**BAKERSFIELD CITY SCHOOL DISTRICT
RELOCATION OF (9) MODULAR CLASSROOMS AND
(1) MODULAR RESTROOM AT FRANKLIN ELEMENTARY SCHOOL
BAKERSFIELD, KERN COUNTY, CALIFORNIA**

Job No. 1348
Appl. No. 15-6
File No. 03-123703

ADDENDUM NO. #03

ITEM • 3-1
REF. DSA APPROVED
DRAWING, SHEET EI.00

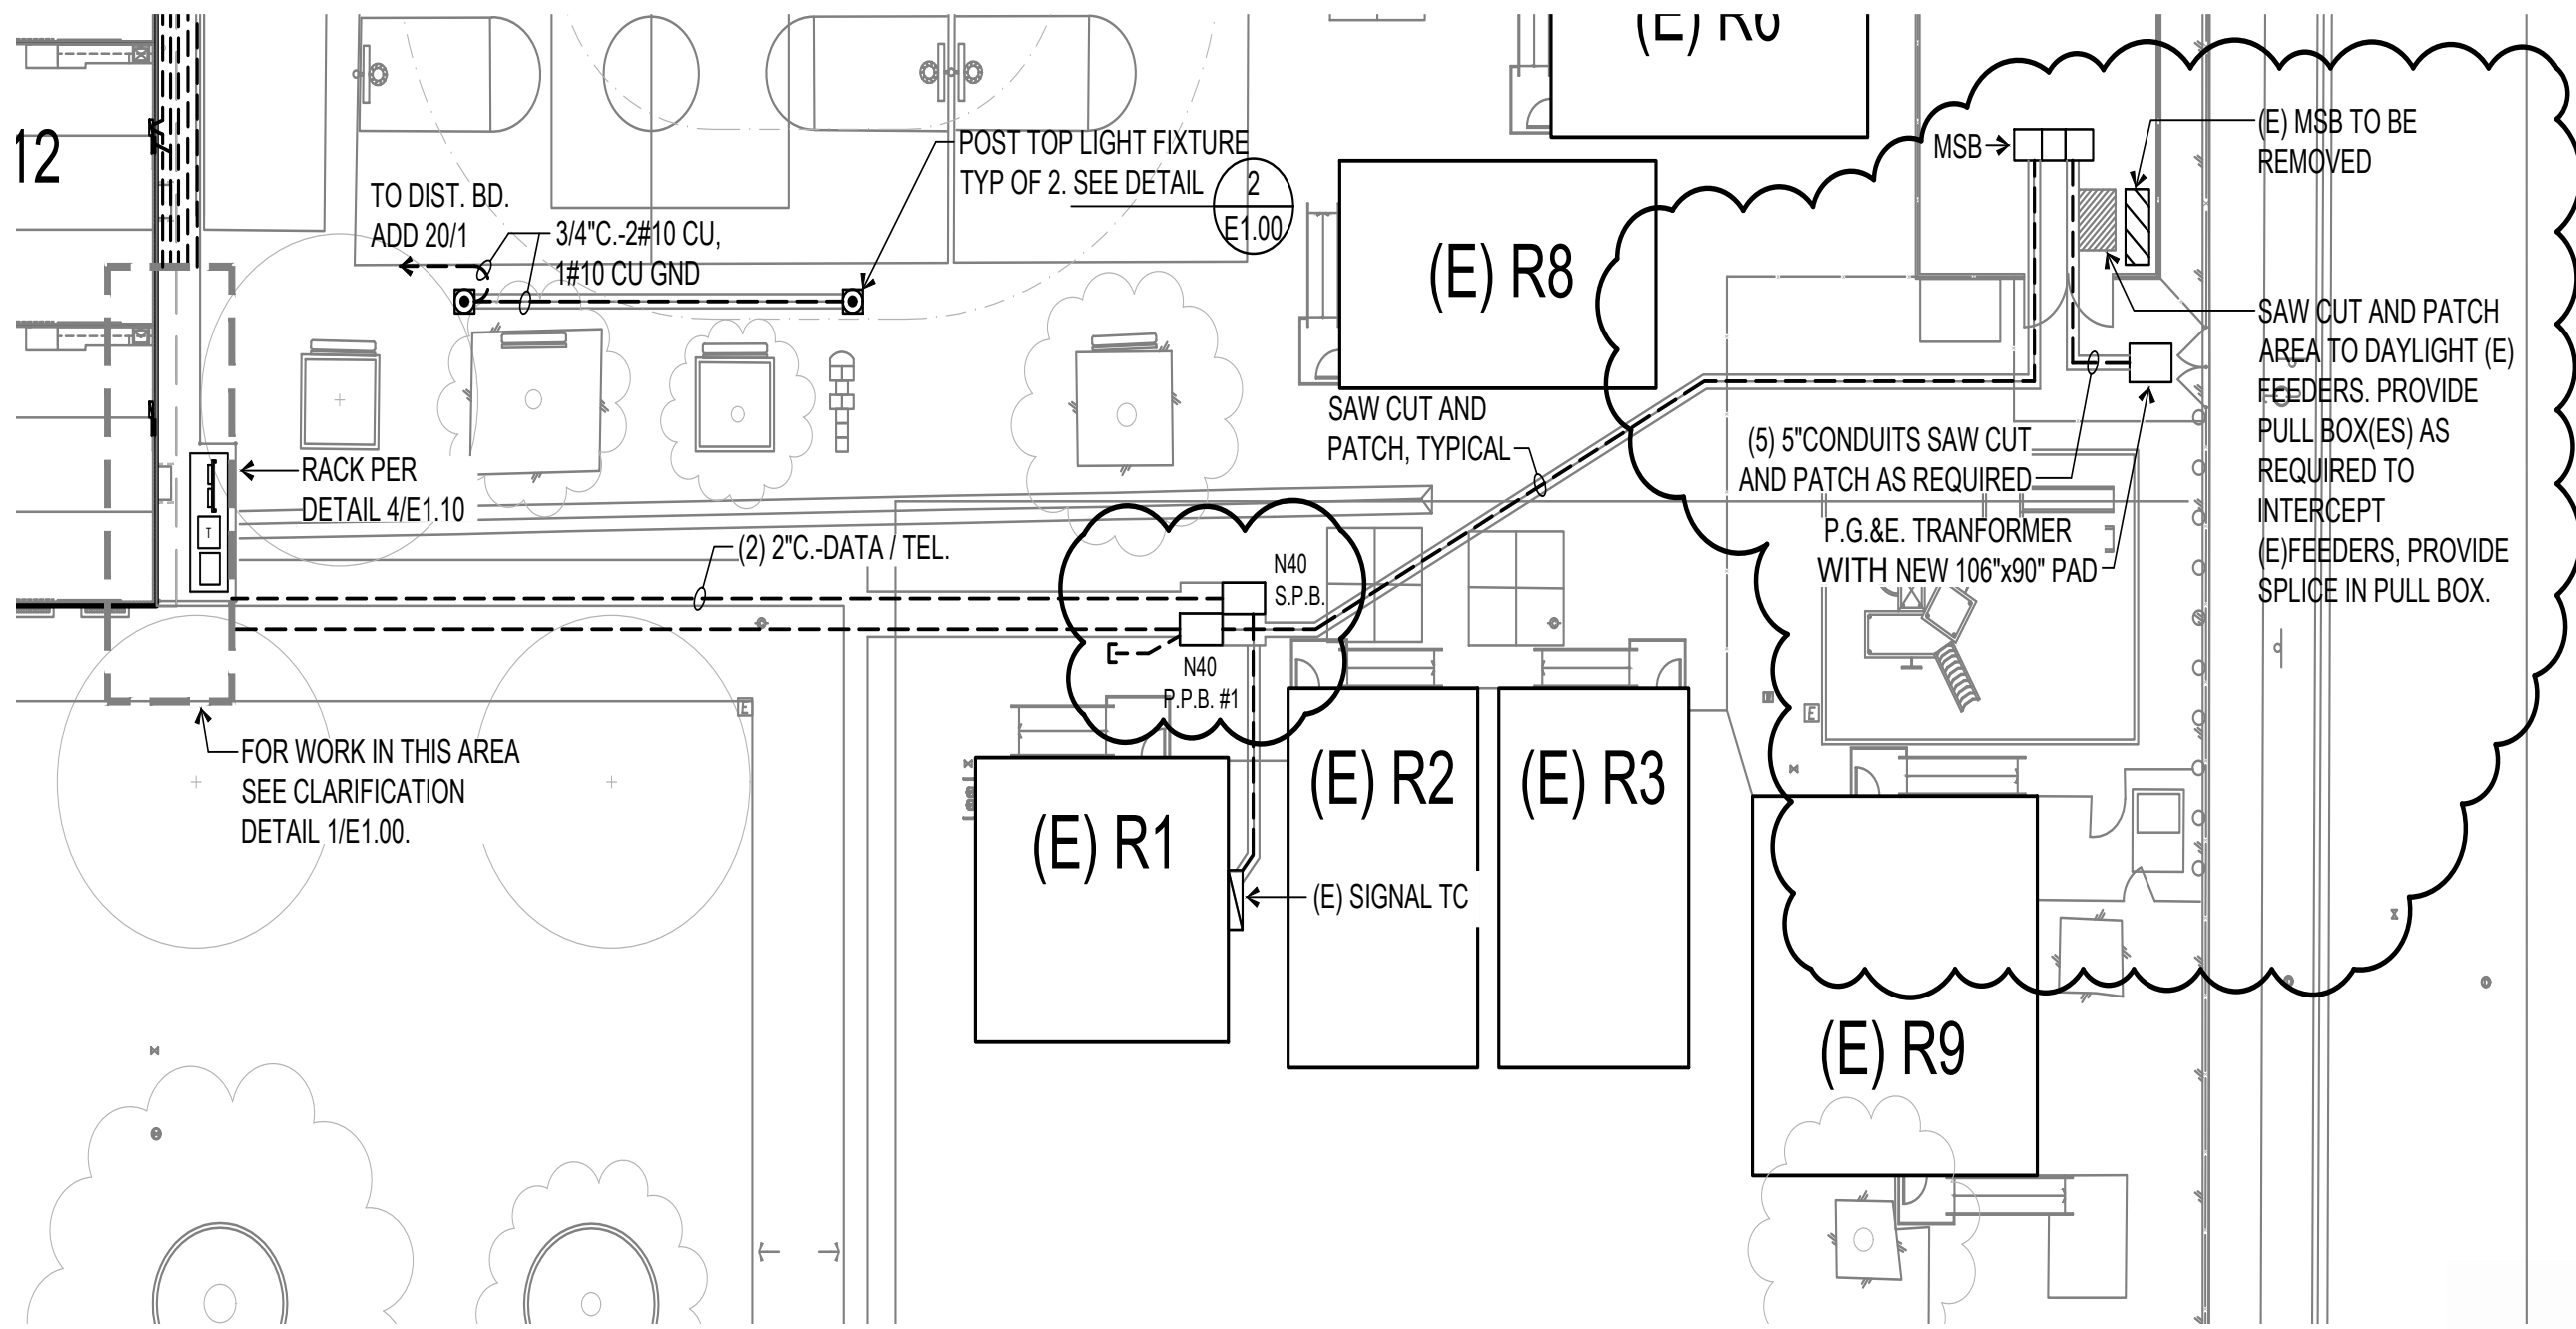
- 3-1) Refer to DSA Approved Project Drawings, Sheet No. E1.00 ELECTRICAL SITE PLAN, SYMBOL LEGEND, DETAILS AND NOTES, ELECTRICAL SITE PLAN;
- a. REVISE: Location of Utility Transformer and pad and location of the (5) 5: conduits from the Utility transformer to the MSB as indicated per attached Drawing No. 01.

- b. ADD: Conduit and cap at PPB#01 as indicated per attached Drawing No. 01.
- 3-2) Refer to DSA Approved Project Drawings, Sheet No. E1.10 ELECTRICAL SINGLE LINE, DETAILS AND SCHEDULES, ELECTRICAL SINGLE LINE DIAGRAM;

ITEM • 3-4a
REF. DSA APPROVED
DRAWING, SHEET C5

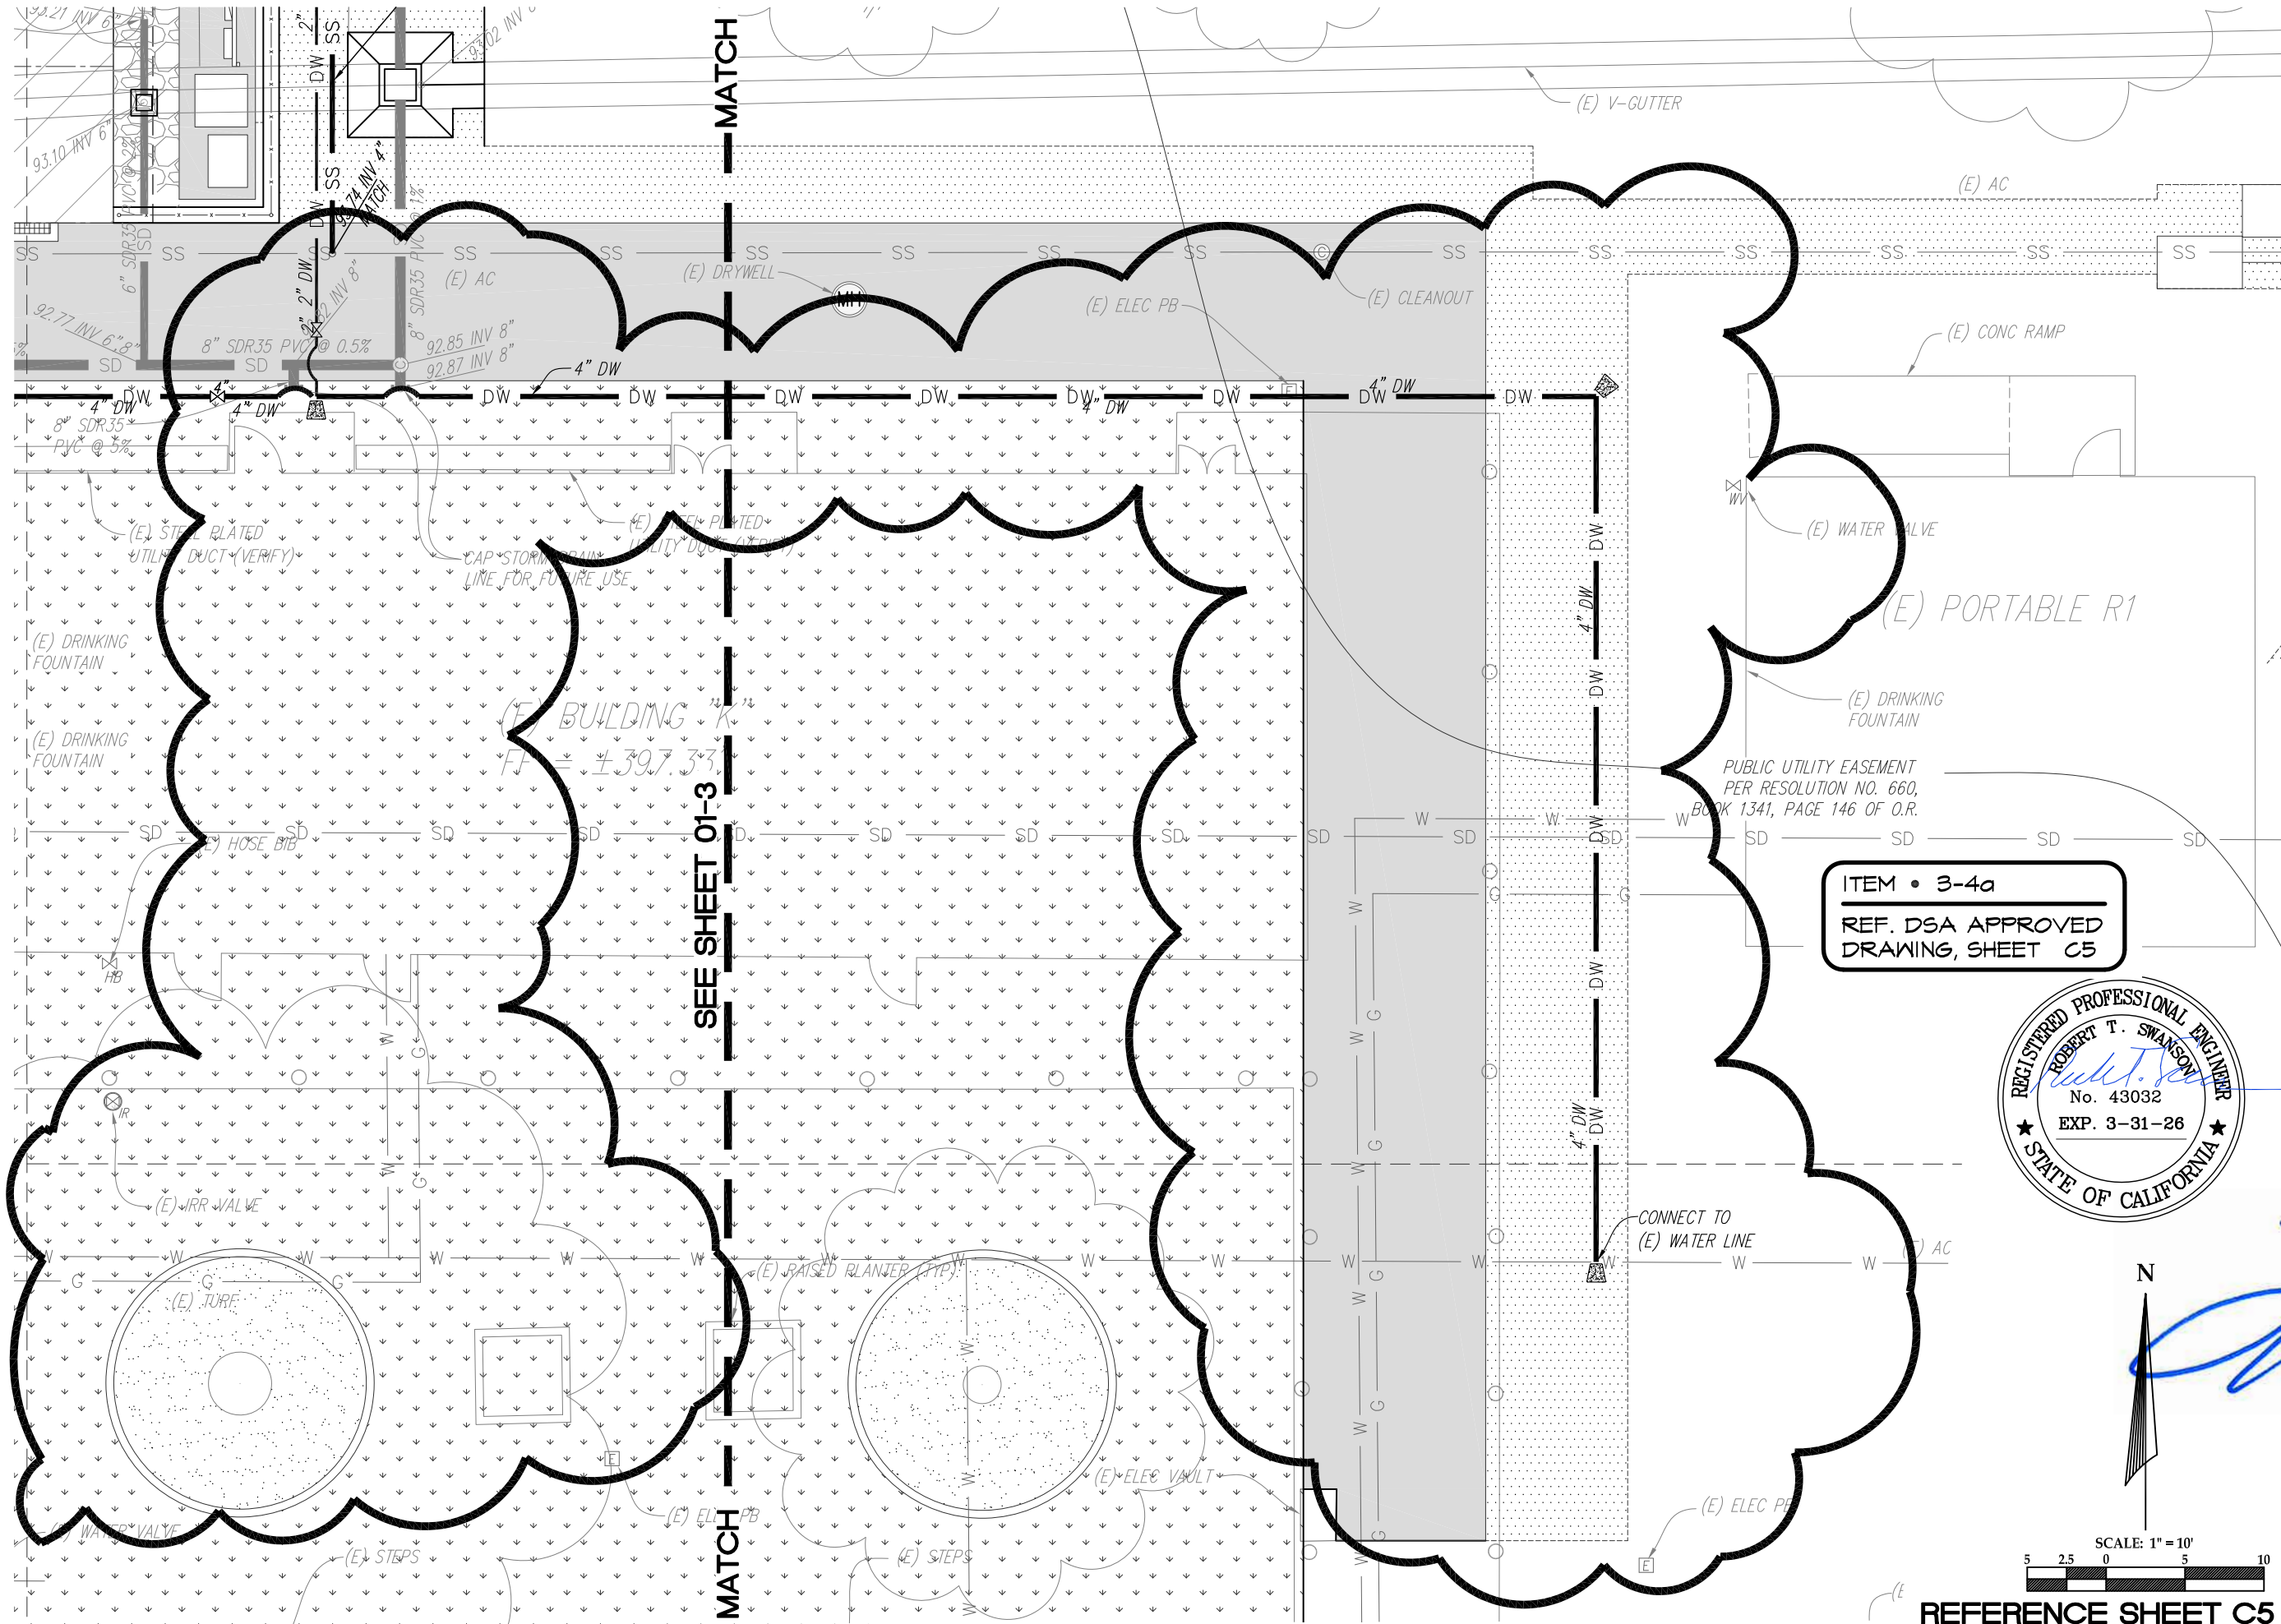
- 3-4) Refer to DSA Approved Project Drawings, Sheet No. C5 SITE UTILITY PLAN and C2 GRADING PLAN;
- a. REVISE: Location of 4" domestic water line that is shown under the footprint of (E) Bldg "K" that is scheduled for demolition to be on the East side of Bldg "K" as indicated per attached Drawing No. 02.

ITEM • 3-4b
REF. DSA APPROVED
DRAWING, SHEET C2

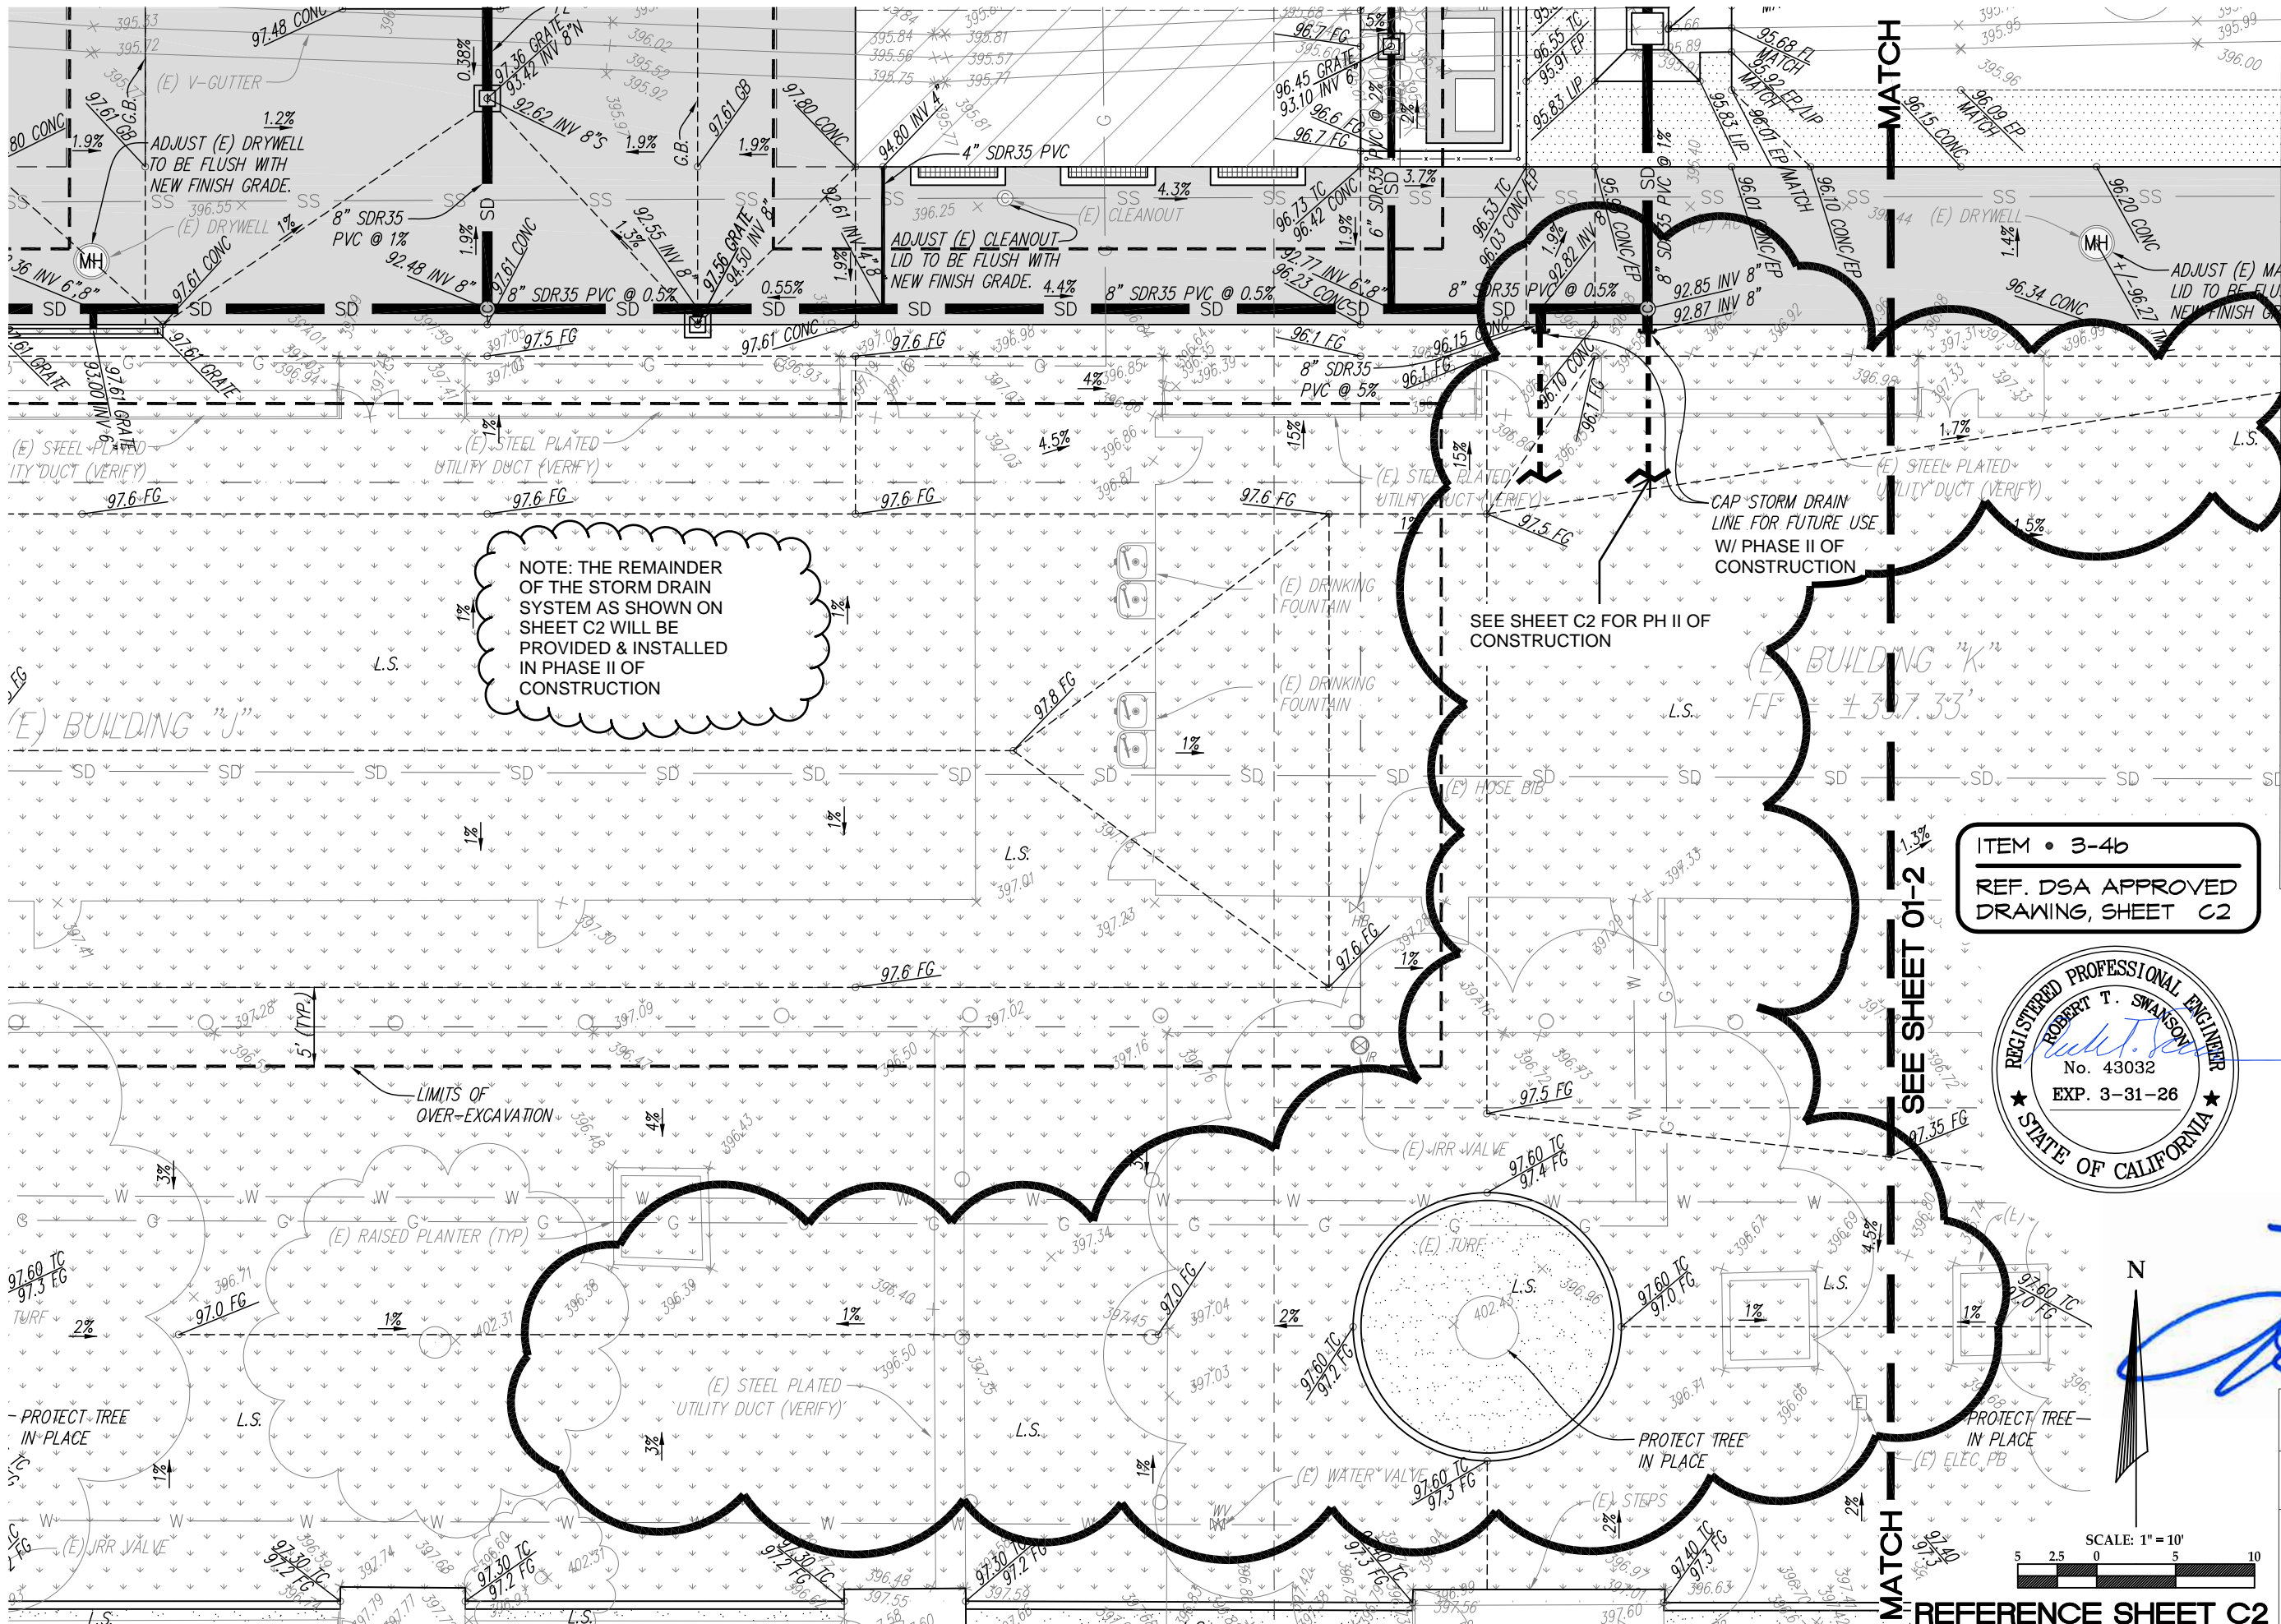
- b. ADD: Cap Storm drain system as indicated per attached Drawing No. 03.
 - c. ADD: Sawcut, demolition and patch back of (E) AC Paving for revised water line relocation as indicated per attached Drawing No. 04.

NOTE: THE REMAINDER OF THE STORM DRAIN SYSTEM AS SHOWN ON SHEET C2 WILL BE PROVIDED & INSTALLED IN PHASE II OF CONSTRUCTION
